**Memorandum
Department of Planning & Public Works**

RE: P.Z. 20-2008 St. Louis Family Church (101 & 139 Valley Center Dr.-17501 Edison Ave.): A request to amend City of Chesterfield Ordinance 2092 to amend the gross floor area and building height requirements for St. Louis Family Church, a 16.17 acre tract of land zoned "PI" Planned Industrial District located at the southwest corner of Chesterfield Airport Rd. and Valley Center Dr. (17U230302, 17U230311, 17U210180)

Planning Commission Staff Report

Petition: P.Z. 20-2008 St. Louis Family Church (101 & 139 Valley Center Dr.-17501 Edison Ave.)

PRELIMINARY DEVELOPMENT PLAN 94-33 5/19/2008 1

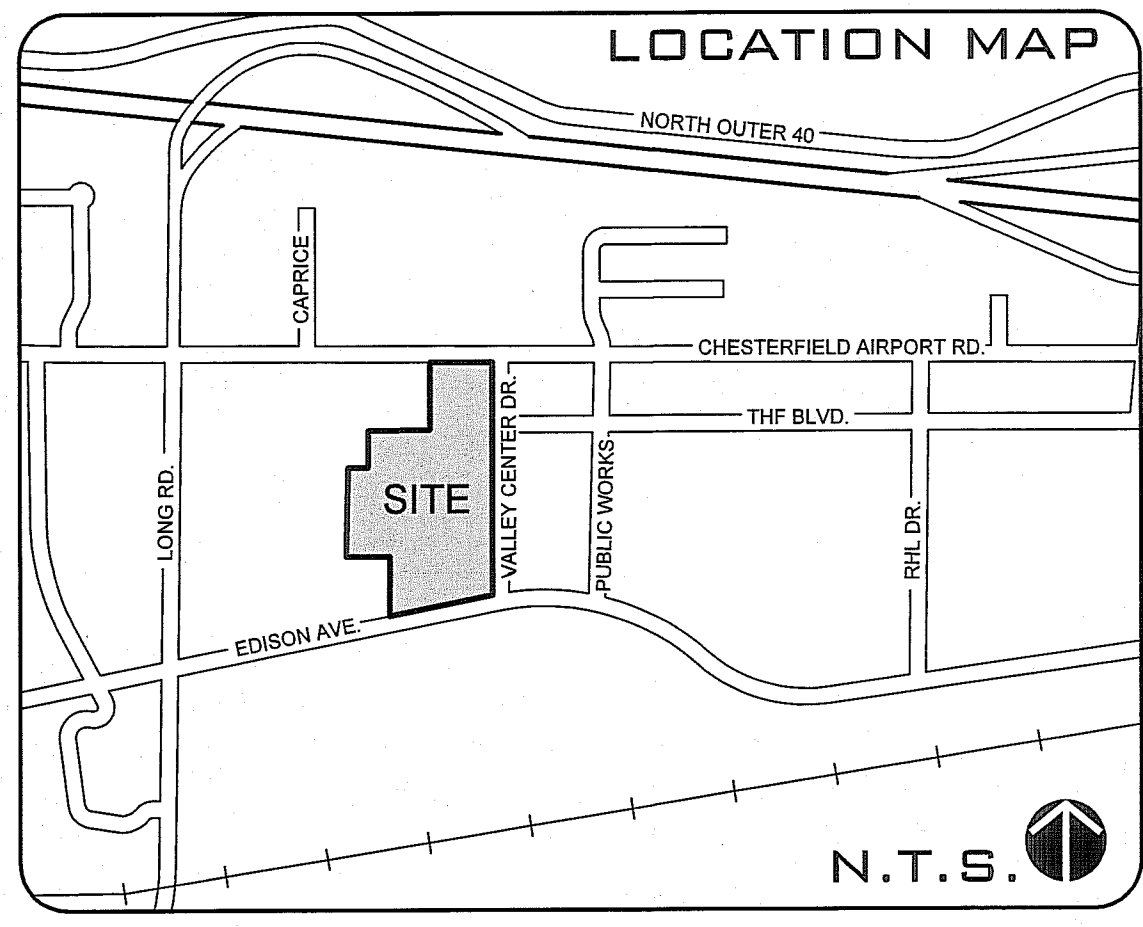
The addition will put the entire building into noncompliance with the 2003 International Building Code. In order to construct a church of nearly 100,000 square feet, it has to meet the requirements for an unlimited area building. One of these requirements is that the building "be surrounded and adjoined by public ways or yards not less than 60 feet in width." The east wall of the proposed building is less than 50 feet from the property line, with the northern 300 feet being only 30 feet from the property line.

In addition the plan does not indicate how tall the building will be. Your Notice of Public Hearing indicates that one of the things that they are seeking to amend is building height requirements. If it's over 30 feet tall, none of the drive aisles around the building will be in compliance.

Petitioner's Response: Petitioner acknowledges these comments and will work with Monarch Fire Protection District to satisfy all requirements for this project.
